# UNITED STATES PATENT AND TRADEMARK OFFICE

APPLICATION NO.	FILING DATE	FIRST NAMED INVENTOR	ATTORNEY DOCKET NO.	CONFIRMATION NO.
10/071,230	02/11/2002	Guenter Koelle	225/50877	9239

<b>Office Action Summary</b>	<b>Application No.</b> 10/071,230	<b>Applicant(s)</b> KOELLE, GUENTER	
	<b>Examiner</b> David S. Warren	<b>Art Unit</b> 2837

Unnumbered element  
discussed below

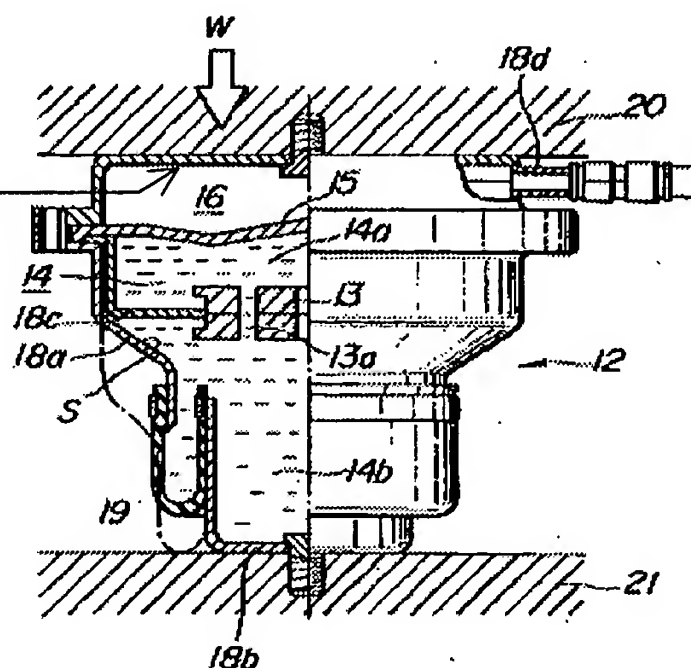
Claims 1 - 9, 11 - 18, 20, 21, and 24 - 28 are rejected under 35 U.S.C. 102(b) as being anticipated by Kimura ('648). Regarding independent claims 1 and 12, Kimura discloses the use of reducing the transmission of sound and/or vibration between components (20, 14) by inserting air cushion (16) between components wherein the air cushion rests directly against both elements 20 and 14.

Regarding claims 20 and 26, Kimura shows two components spaced from one another (20, 14), an air cushion placed between the components and having respective air cushion cover surface sections (15, and the unnumbered element shown above), wherein the air cushion includes an internal cavity connectable with a pressure source (17) to increase pressure within the air cushion and press the cover surface sections toward the respective components so that the cover surface sections contact (and rest against) the respective components when in the installed position thereby forming a sound muffling assembly between the components. Regarding claims 2 – 4 and 21, the air pressure of Kimura's system may be adjusted after installation (see col. 2, lines 47 – 49). As in the previous Office Action, the term "slight" is a relative term, the applicant has not provided a standard for comparison. Regarding claims 5 and 14, the elasticity of the cover is inherent since Kimura discloses that the height of the seat may be adjusted by adjusting the air pressure (col. 3, first paragraph). Regarding claims 6 and 15, any material, at some frequency, will be "muffler-active." Regarding claim 7, 8 and 16, the air cushion of Kimura must be gas tight, otherwise "pressure" could not be adjusted and controlled and the cushion takes the "approximate" shape between the components. Regarding claims 9, 17, and 24, a "blower" is defined as "a device for producing a current of air" (Webster's New World Dictionary, College Edition, 1966), Kimura uses phrases that inherently indicate a current of air, e.g., "air inlet" and "air feed duct" (col. 2, lines 46 and 47). Regarding claims 11 and 28, Kimura shows that elements 18a and 18b are moveable with respect to one another by changing the volume of "S" (i.e., by changing air pressure in 16), any change in dimension of "S" will

inherently alter the frequency muffled. Regarding claims 13 and 18, air cushion has a gas supply opening 18d (fig. 2). Regarding claims 25 and 27, the “unnumbered element” and element 15, of Kimura appear to be different thicknesses (see fig. 2).
